## City of Auburn, Maine

**To:** Auburn Planning Board  
**From:** Megan Norwood, City Planner II  
**Re:** North River Road (PID 271-101), Final Plan: Proposed 3, 12-Unit Apartment Buildings and associated parking, driveways, landscaping, utilities, & other site improvements in the General Business Zoning District (West Shore Landing Apartments).  
**Date:** February 11, 2020

Figure 1: Plan Showing the Composition of Uses Adjacent to the North River Road Parcel with green being Multifamily, yellow being Single Family and Pink being Commercial.

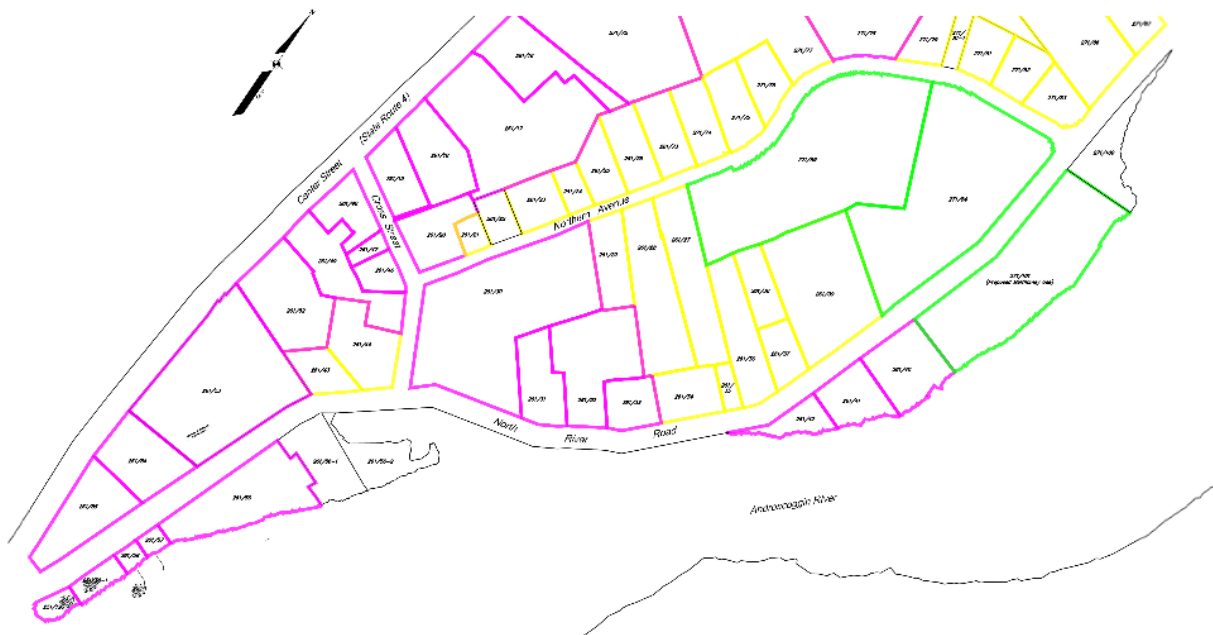
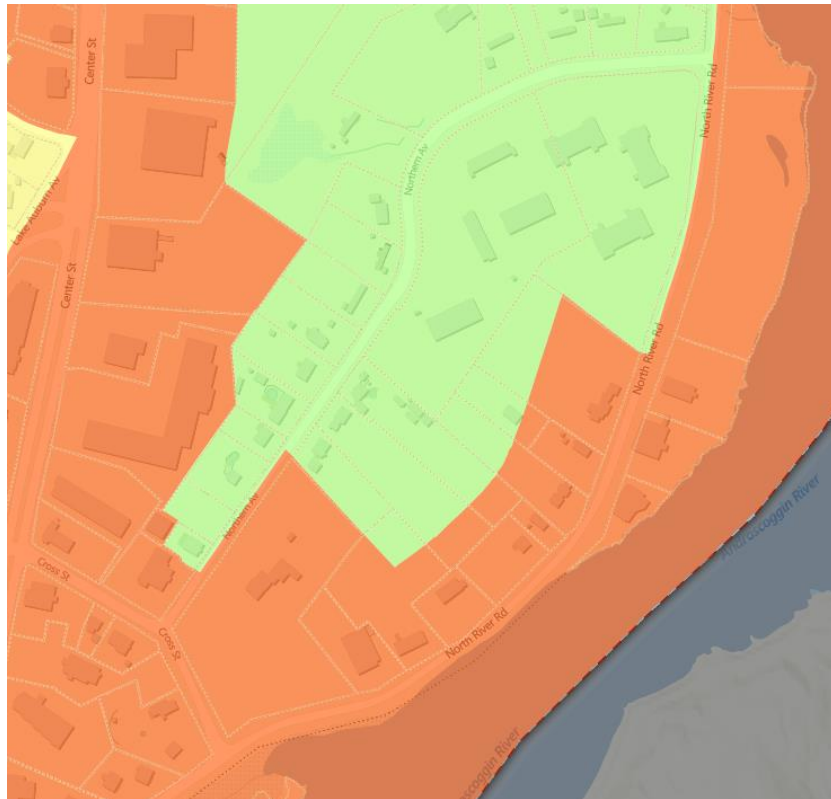
Section 3 of the Applicants response does a good job demonstrating the composition of land uses in the neighborhood. Interestingly, the Multifamily Suburban District generally allows for some less intense commercial uses as Special Exceptions reviewed by the Planning Board (such as libraries, professional offices, cemeteries etc.) but these uses are not located outside of the General Business area in this specific neighborhood. The uses in the neighborhood align almost exactly with the Zoning Map (*See Figures 1 and 2 below*).

The pink areas in Figure 1 are commercial uses, the yellow areas are single-family homes and the green areas are multifamily developments (including this proposed development). There are some yellow and green (residential uses) in the General Business District which is to be expected since residential uses are allowed in the General Business District at the same density as the Multifamily Suburban District. However, the Multifamily Suburban District allows for commercial uses as Special Exceptions reviewed by the Planning Board, yet we do not see them outside of the General Business District in this neighborhood. The single and multifamily residential uses are clustered together, and the commercial uses are clustered together. It is Staffs opinion that this project does fit in with the character of the neighborhood.
